Request
Project Name
Council District
Requested by

Modifications to DTC Standards
Hyatt Regency – Nashville Yards Parcel 1
19 – O’Connell
Ragan-Smith Associates, Inc., applicant; Uptown Property Holdings, LLC, owner

Modifications to the Downtown Code

Downtown Code DRC Meeting of 12/07/2017

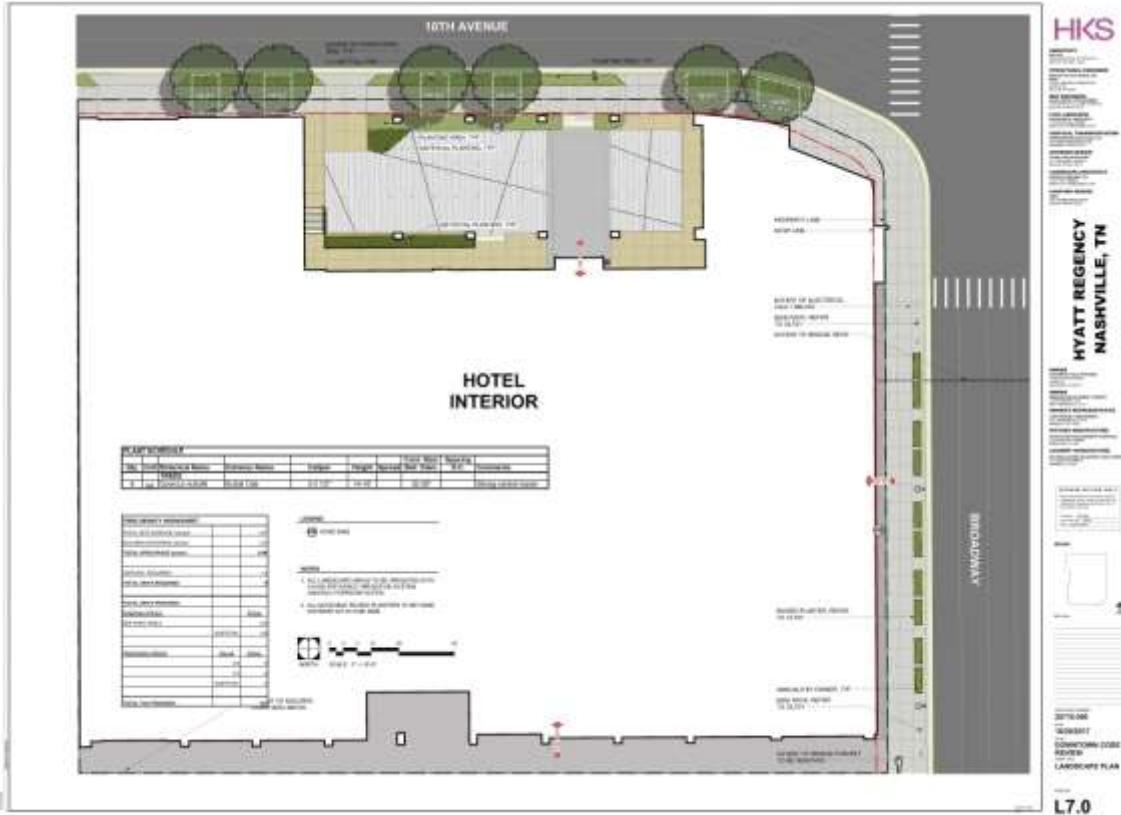
An 80% minimum facade width with active use is required along the 10th Avenue South ground floor. The project proposes a porte-cochere drop-off that cuts into this frontage to allow for safe vehicular drop-off of hotel guests. The building continues above the porte-cochere and the upper stories of the podium are within the build-to zone, maintaining an upper level facade width over 80%. The drop-off zone will provide an element of liveliness to that frontage as people arrive at the front entry to the building. Given the scale of the hotel, such an off-street drop-off zone will be less disruptive to street and pedestrian traffic than an on-street solution. That said, there are still blank areas of the ground level facade along the sidewalk that should be further articulated to add more variety to the pedestrian realm along 10th Avenue.

1. Add articulation to the facade areas along the ground level of 10th Avenue North, to further add interest to the pedestrian realm, staff to review prior to final site plan approval.
2. Applicant to continue to work with the Transportation Division and Metro Public Works on a bikeway connection between 10th Avenue North and their proposed boardwalk/greenway through to Church Street. This may include bike facilities on the Broadway, 10th Avenue North, and/or their proposed boardwalk/greenway, staff to review prior to final site plan approval.

Site Plan

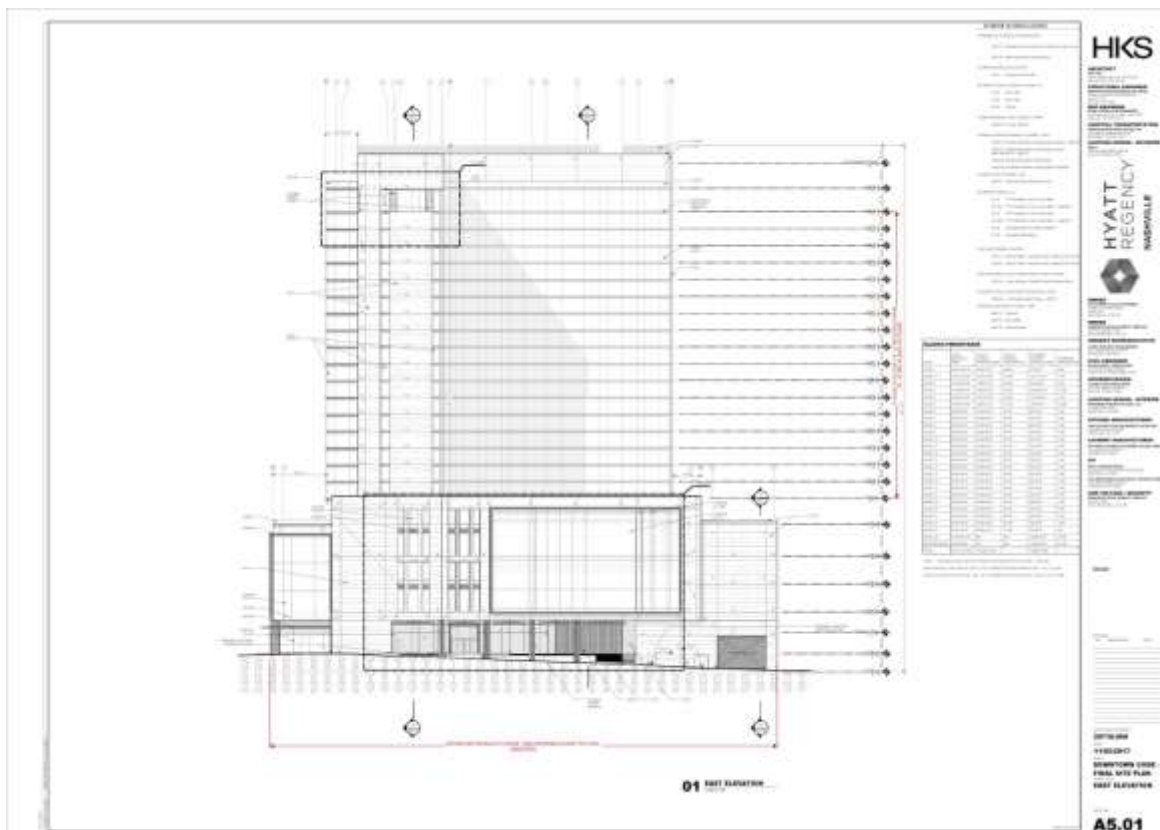
Along Broadway, the applicant is proposing to meet or exceed the full streetscape dimension ranging from 19' for the majority of the frontage, with a narrow pinpoint of 11.9' towards the corner of 10th Avenue. However, due to the Broadway bridge deck over the adjacent CSX railway and the proposed placement of transformers, no street trees are proposed along this frontage. Instead, 2.5' x 9' planters with perennials are proposed (street trees are provided along 10th Avenue as required). Given the physical constraints, the inclusion of street trees along the Broadway frontage may be unfeasible. A bikeway connection should be considered curbside in lieu of the planters, in order to connect planned 10th Avenue bike facilities to this project's boardwalk/greenway (along the CSX rail property line), through to Church Street. Such a connection will need further coordination and study by our Transportation Division and Metro Public Works, in conjunction with the applicant team.
